18:20 June 08, 2018 License HI 267 Page 1 of 25 Sample Lintel 04-22-2018.alb6

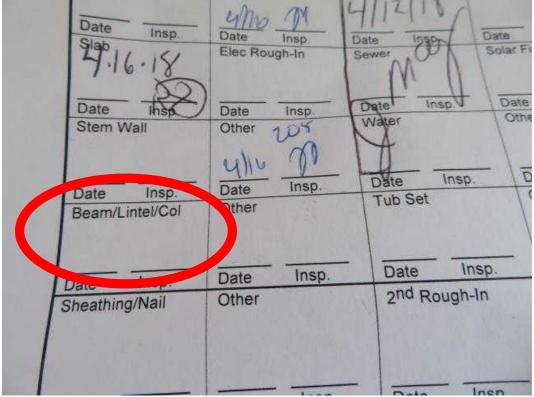
#2 2 dowels improperly placed. Missing footer dowels: at patio, left side near front, right side near center, left front of garage
